PLANNING DIRECTOR'S SPECIAL PERMIT
 1231 "I" STREET, SUITE 200, SACRAMENTO, CA 95814

B. Planning Director's Special Permit for a Deep Lot Development consisting of two single family homes on one parcel totaling 1.0± acres in the Standard Single Family (R-1) zone.

LOCATION: 5640 71st Street

P91-109

LEFT ELEVATION
SCALE 3/8" = 1'-0"

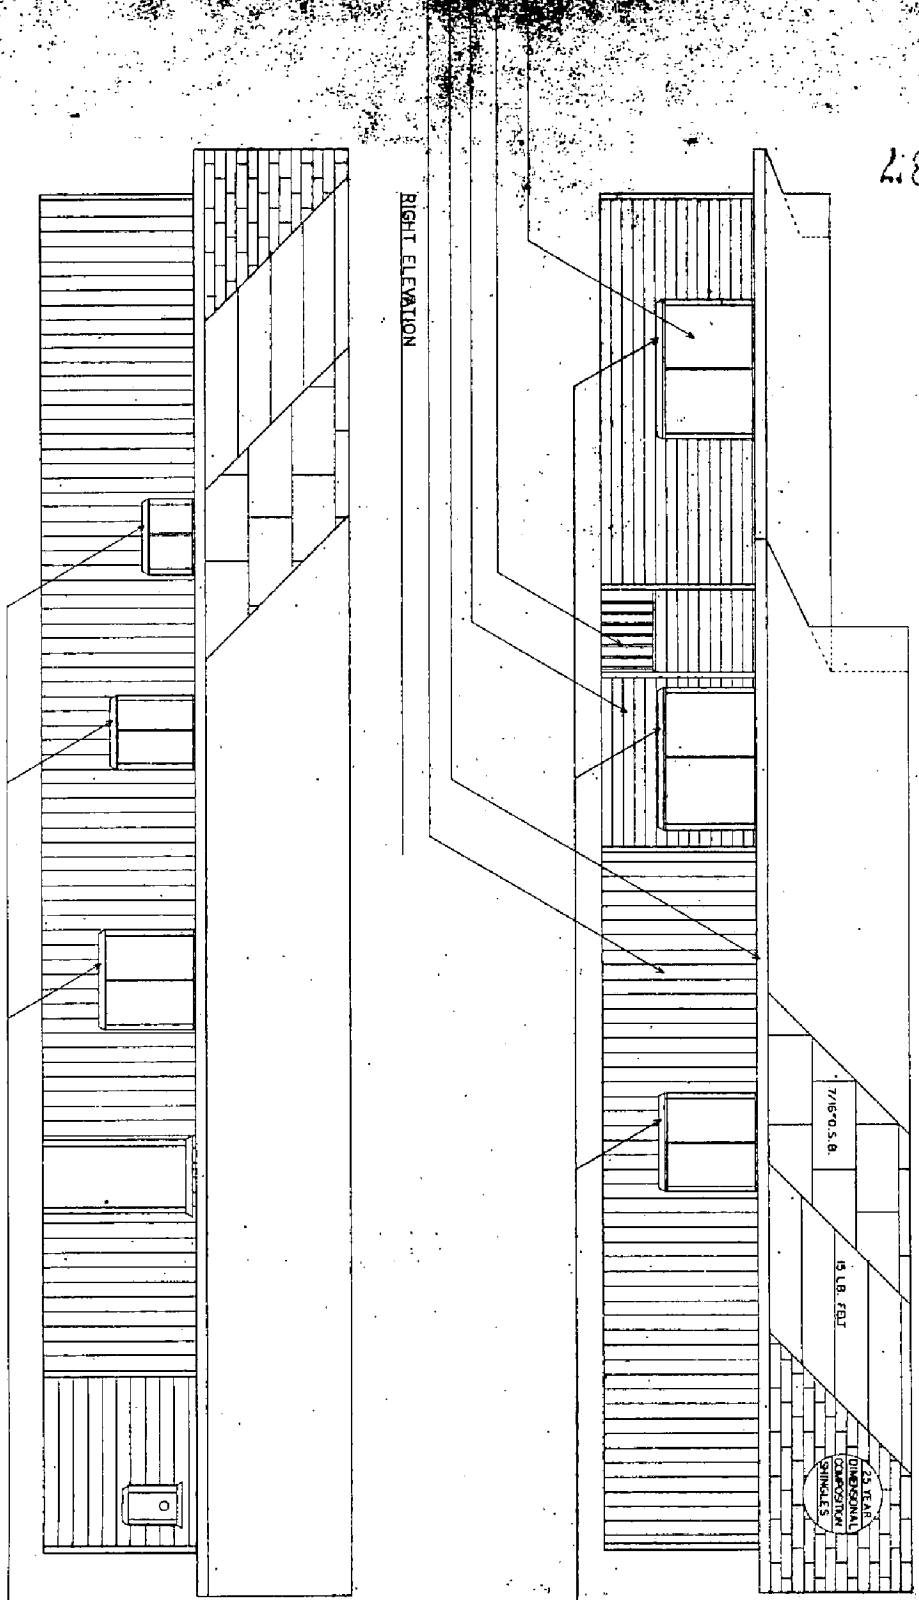
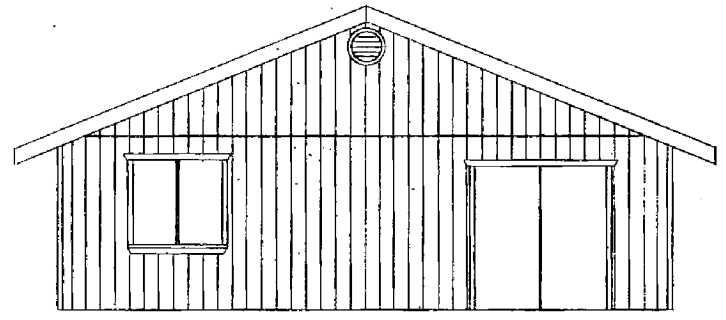
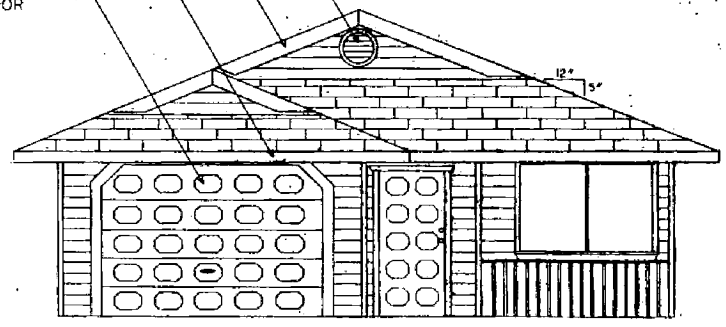
The elevations indicate the exterior building materials to consist of lap siding and T1-11, with the roof material as composition shingles. Staff has reviewed the design with a member of the Design Review staff and suggests revised elevations be submitted for the review and approval of Design Review staff. The revised elevations should include a pair of single hung windows with heavy trim on the front elevation, and for the window on the side of the garage. The applicant should provide the 8" horizontal lap siding as shown on the elevations with the T1-11 on the sides and rear. The T1-11 should have a base and corner trim. The roof material should be laminated dimensional composition with a minimum of 25 year rating as indicated on the submitted plans. The applicant should also work with Design Review to include design features which the two units appear different, as well as the location of any yard area fencing.

- 1. The applicant shall landscape and irrigate the front yards of the units. The landscaping shall consist of, at a minimum, sod with a tree in front of each unit.
- 2. The applicant shall submit revised elevations for the review and approval of Design Review staff. The elevations should include a pair of single hung windows with heavy trim on the front elevation, and for the window on the side of the garage. The applicant should provide the 8" horizontal lap siding as shown on the elevations with the T1-11 on the sides and rear. The T1-11 should have a base and corner trim. The roof material should be laminated dimensional composition with a minimum of 25 year rating as indicated on the submitted plans. The applicant should also work with Design Review to include design features which make the two units appear different, as well as any yard area fencing.

98' SEAT 71st STREET

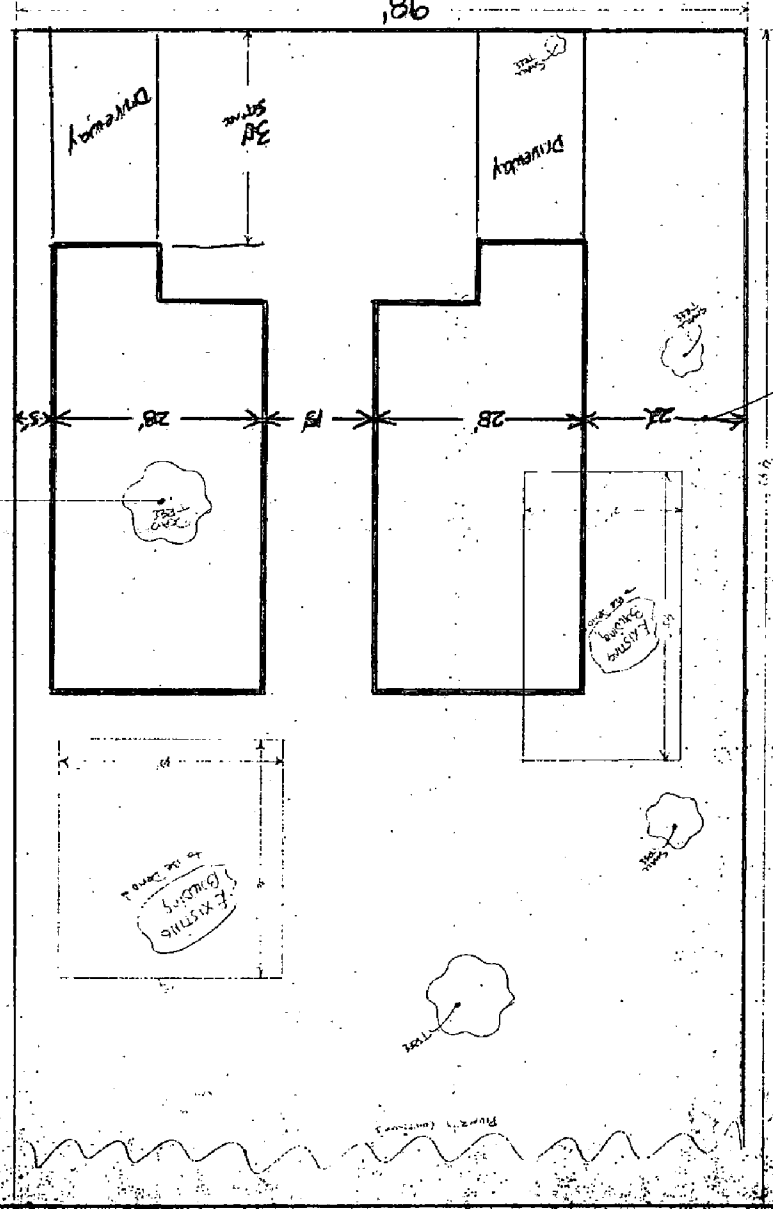
The applicant should landscape and irrigate the front yards of the units. The landscaping should consist of sod with a tree in front of each unit.

- 1. The following trees shall be saved:
 - o 13" Black Locust located on the southeast portion of the lot
 - o 11" and 11" codominant Mulberry located on the southwest portion of the lot.
- 2. The saved trees (13" Black Locust, 11" and 11" codominant Mulberry) shall have a six foot high construction barrier installed around the dripline of each tree prior to the commencement of grading on site. This not shall be included on the grading and/or site plans submitted for building permits.
- 3. No surface or grade changes, no trenching, no parking of vehicles, and no storage of materials shall take place within the fenced in areas around the driplines of trees to be preserved.
